**Case No. P20-09
203 Lafayette Rd.**

CITY of MEDINA
Planning Commission
July 9, 2020 Meeting

Case No: P20-09
Address: 203 Lafayette Road
Applicant: Tony Cerny, Architect representing Brandon Janis (owner)
Subject: TCOV-Certificate of Appropriateness – exterior cooler building addition
Zoning: C-2, Central Business District
Submitted by: Jonathan Mendel, Community Development Director

2 NORTHEAST ELEVATION
SCALE 1/4" = 1'-0"

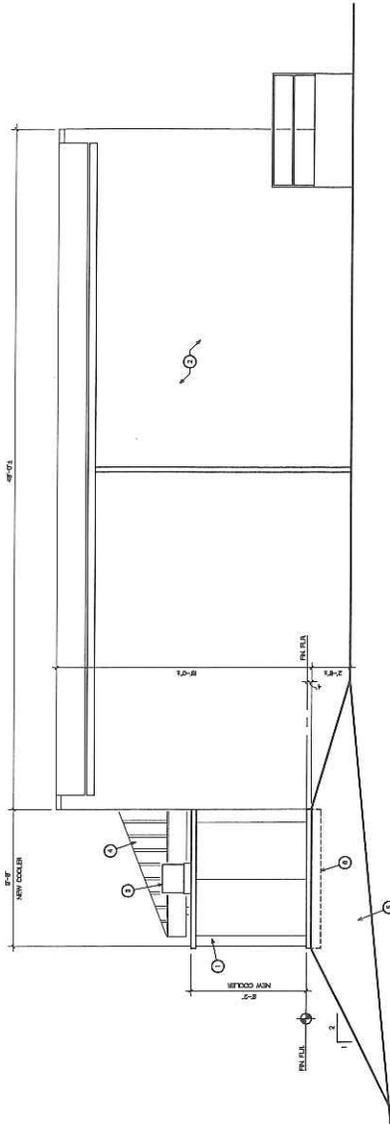
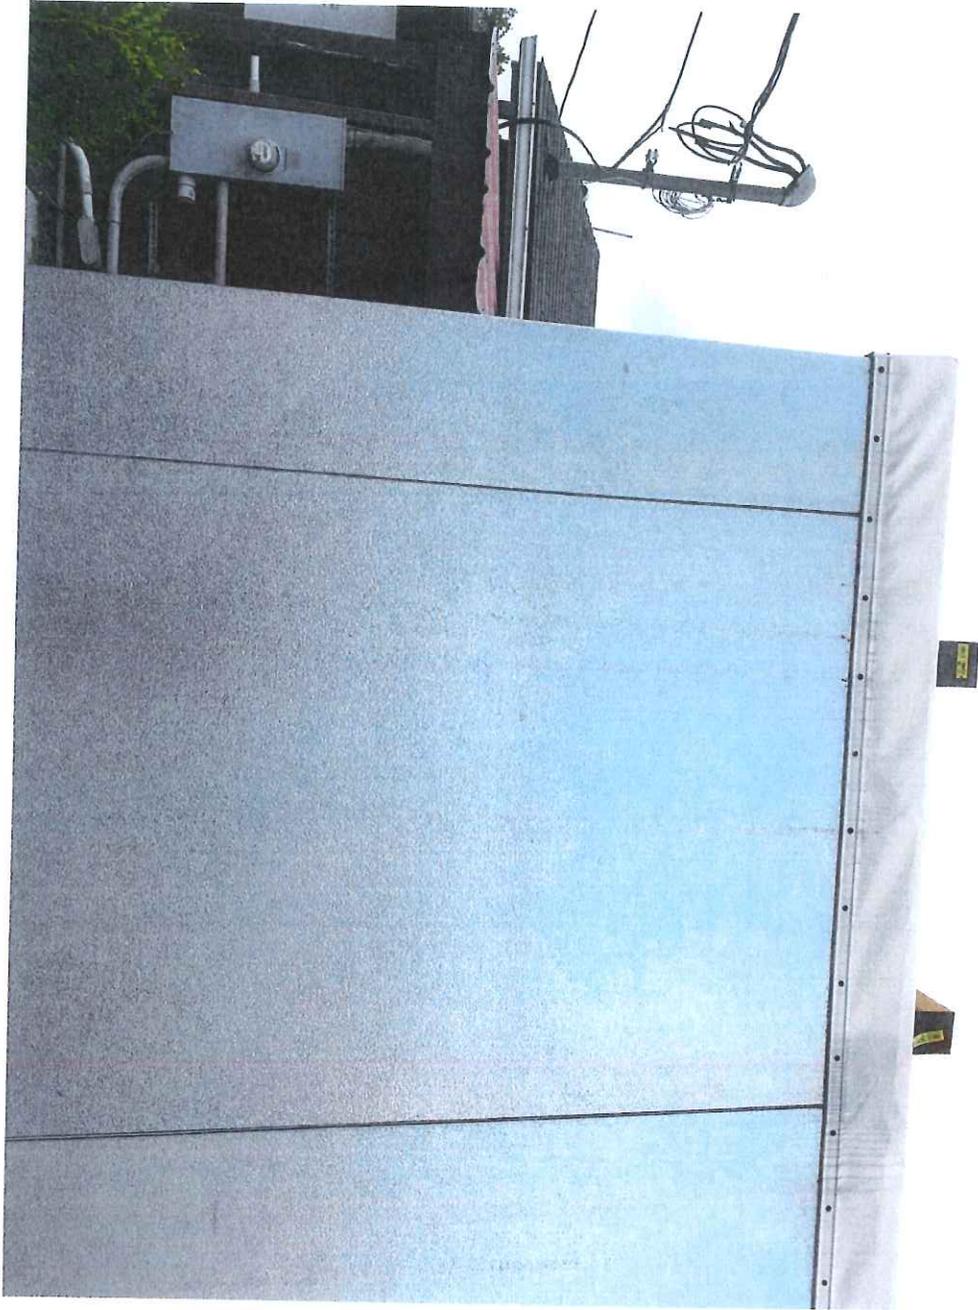
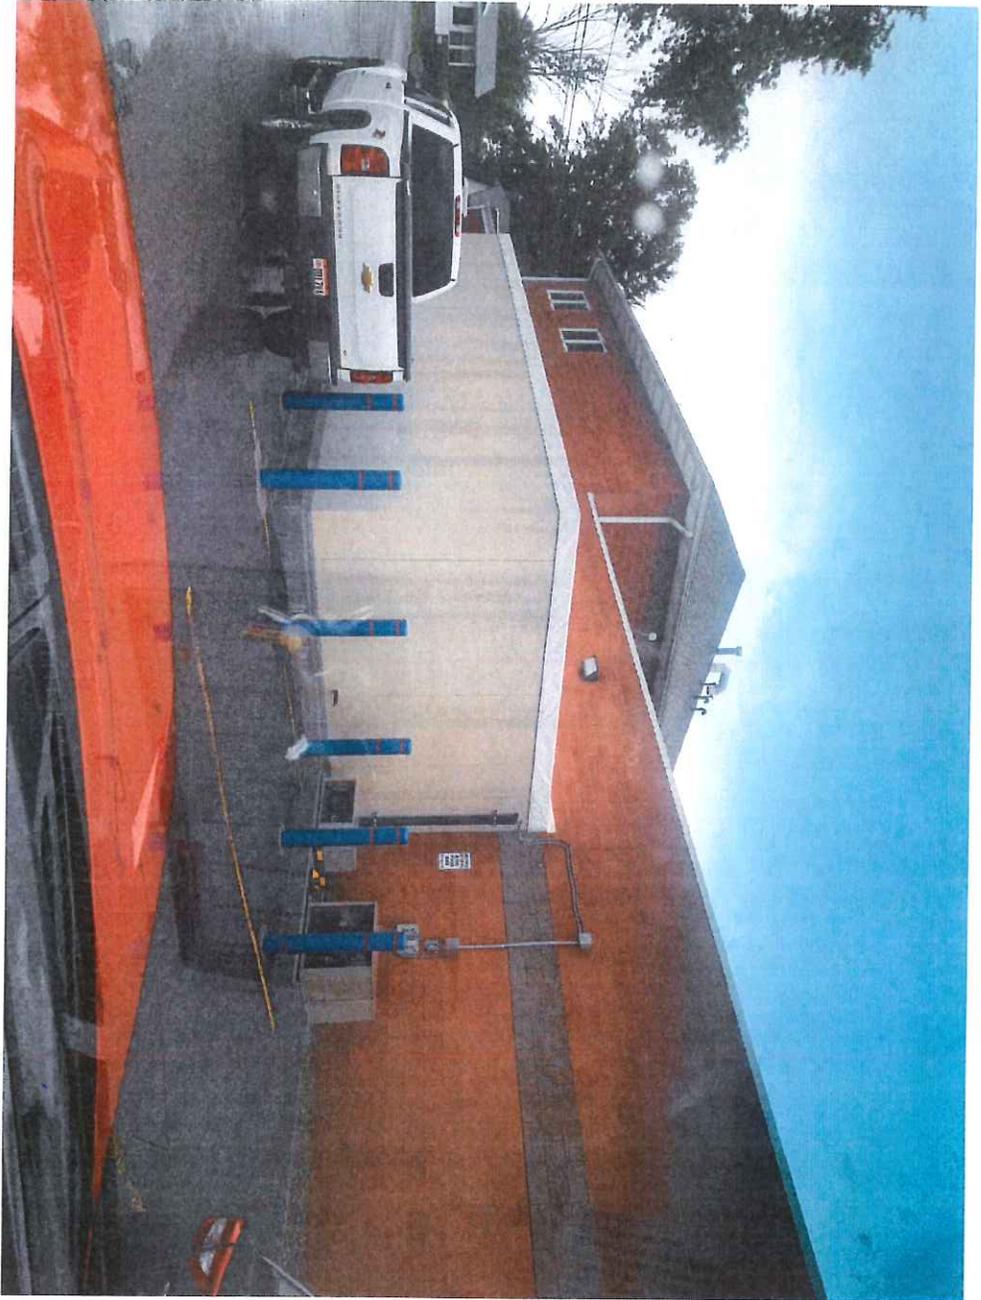
After reviewing the proposal, the applicant plans to paint the exterior steel panels of the cooler unit to match the existing building. This is an appropriate exterior treatment given the location of the addition on the rear corner of the building and furthest from the primarily public rights-of-way near the subject property. This treatment will meet the intent and letter of the above TCOV guidelines.

Staff recommends the Planning Commission **approve** the request subject to the following conditions:

1. Review and approval of applicable permits by the City of Medina Building Department.
